Town of North Castle Bid

DRILLING SERVICES For Test Wells In The Bedrock Aquifer

Addendum #1

PROPOSED BEDROCK TEST WELL LOCATIONS
WITH SEDIMENT EROSION CONTROL

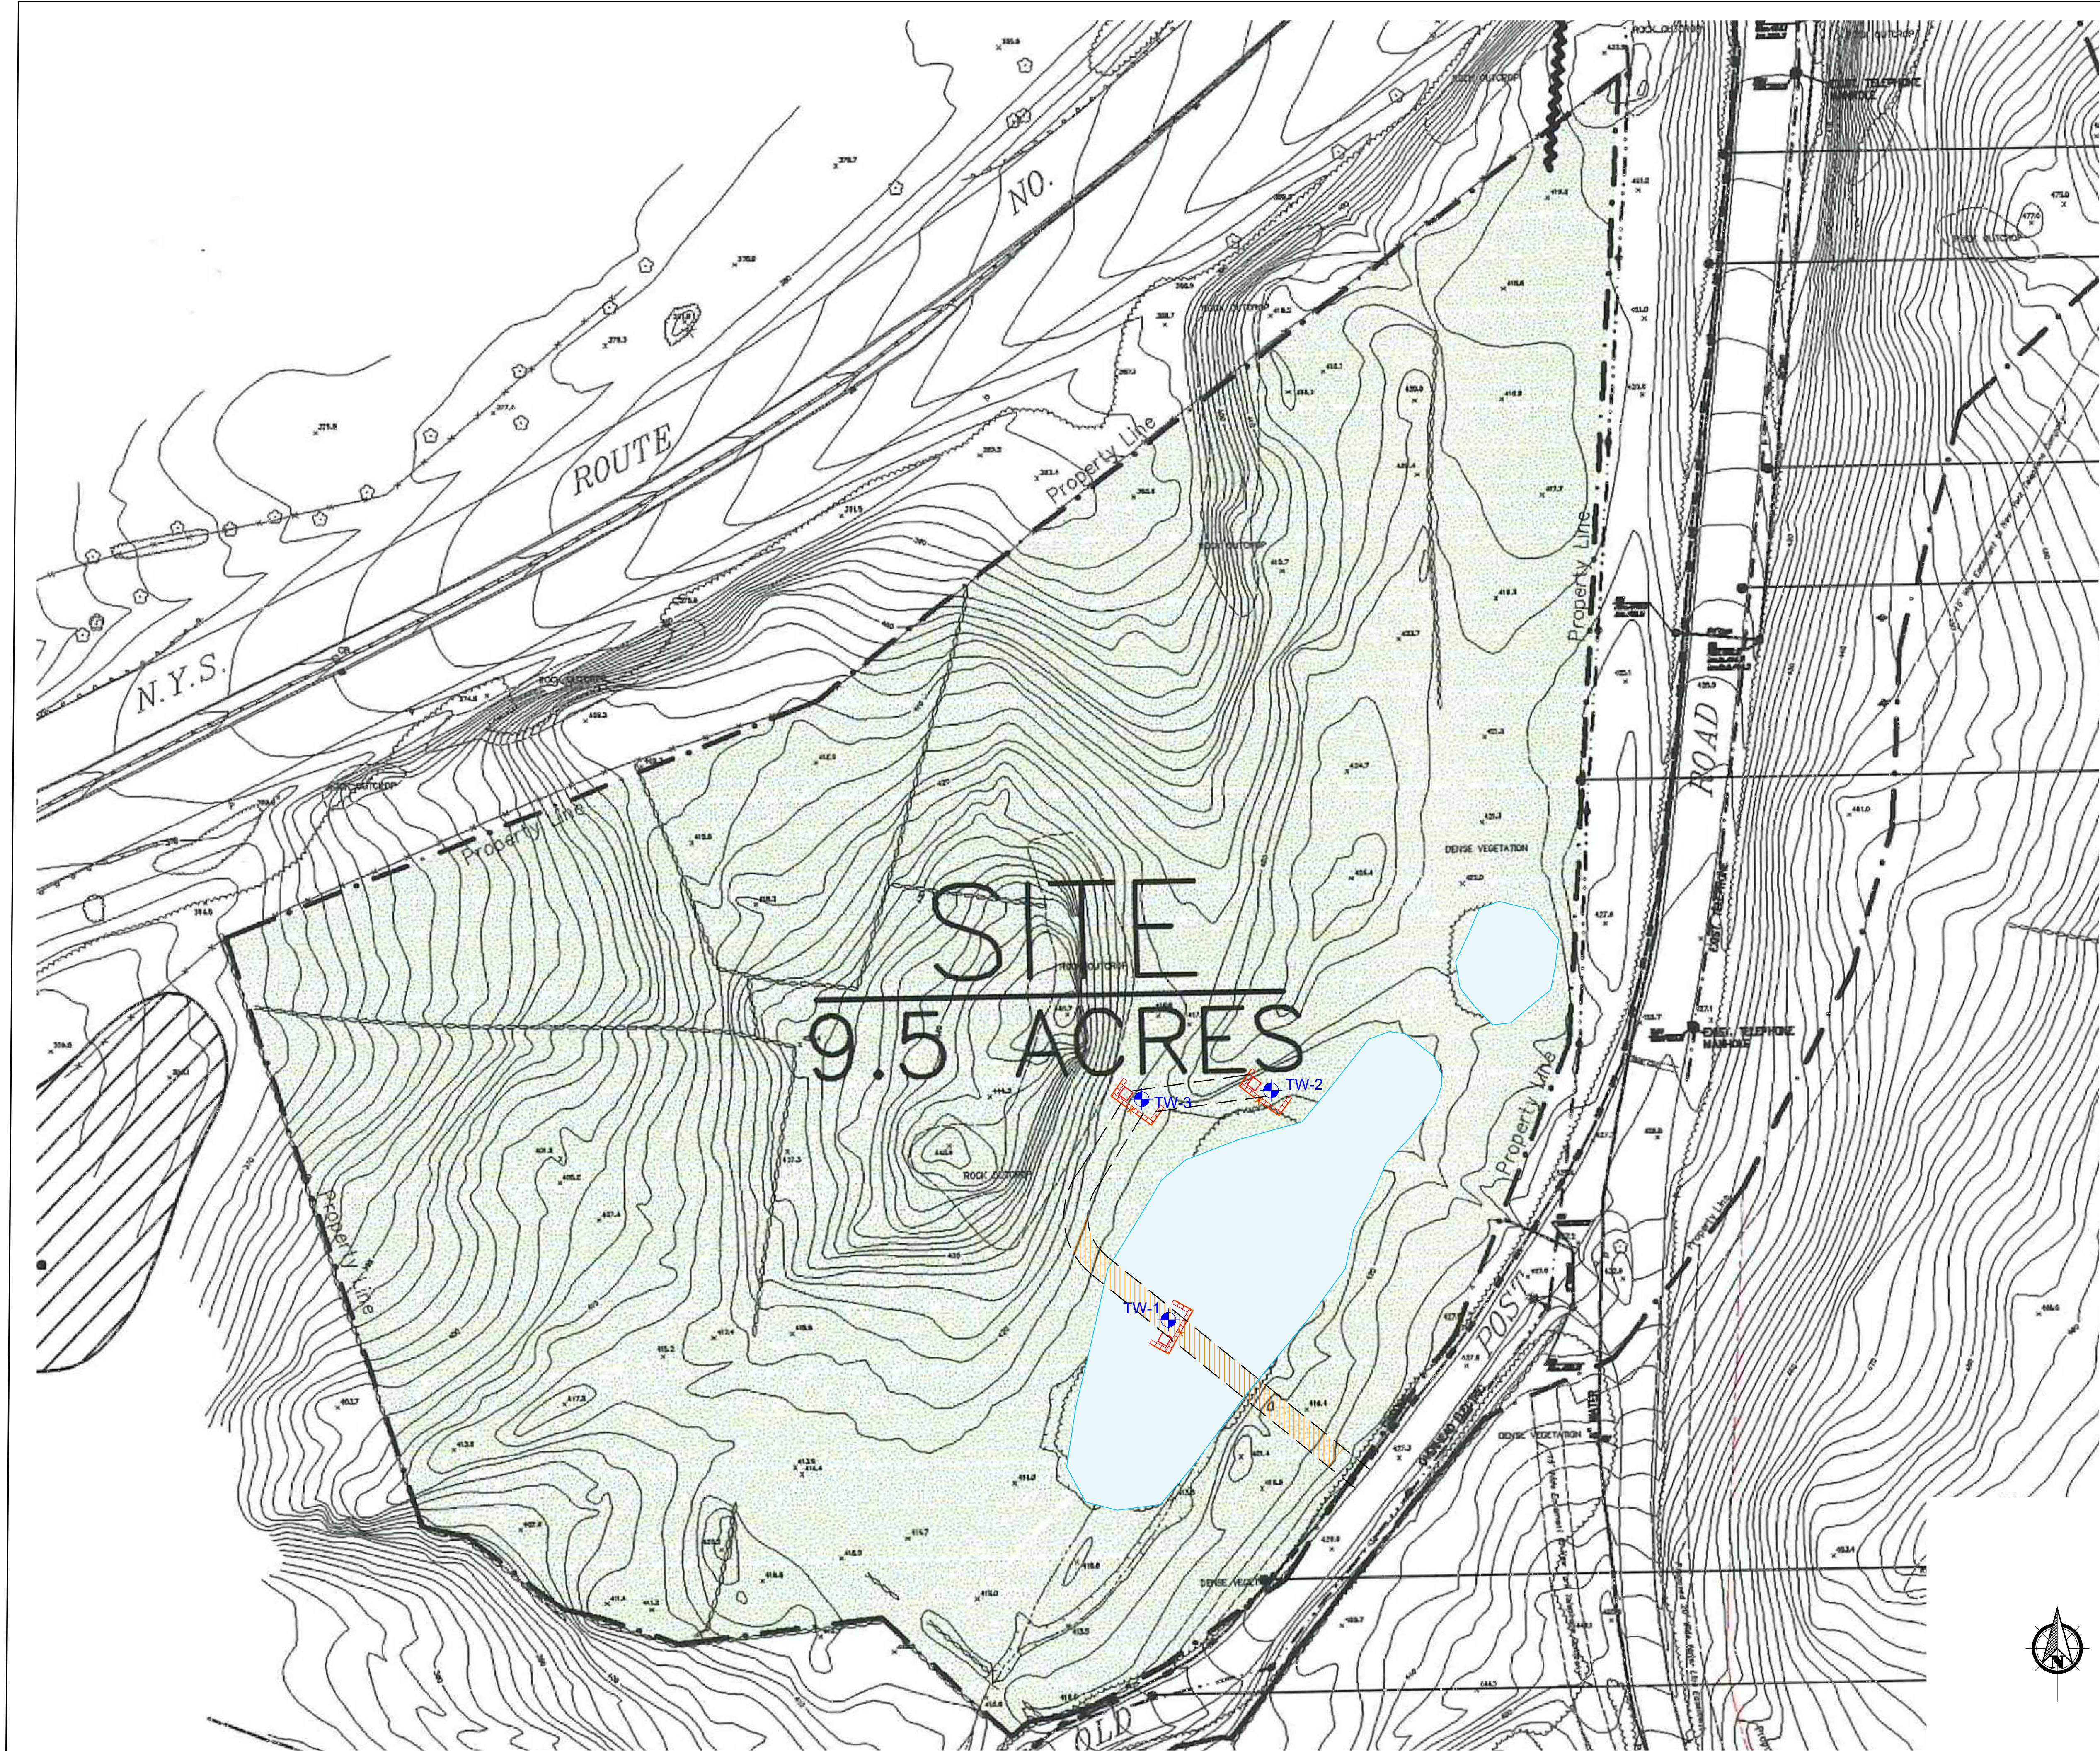
1. The driller will be responsible for clearing an access way from the Old Post Road to the test well locations (see attached plate). Tree/brush clearing and limited grading will be required for the drill rig to access the test well locations. The driller will be responsible for clearing a maximum 12-foot wide path free of brush and small diameter trees and complete light grading in order for the drill rig to reach the proposed locations. A stabilizing fabric extending the maximum length of 200 linear feet should be placed to bisect the wetland feature (attached plate) under a minimum of 4 inches of clean appropriate road construction material (up to 12 inches in the wetland area) to access TW-1. The driller will be responsible for clearing the immediate area around the well site (approximately 20 feet by 20 feet) for the drill rig work space. This cost corresponds to Item 3. of the bid document. Please also include a separate cost to remove the fill/fabric, if necessary.
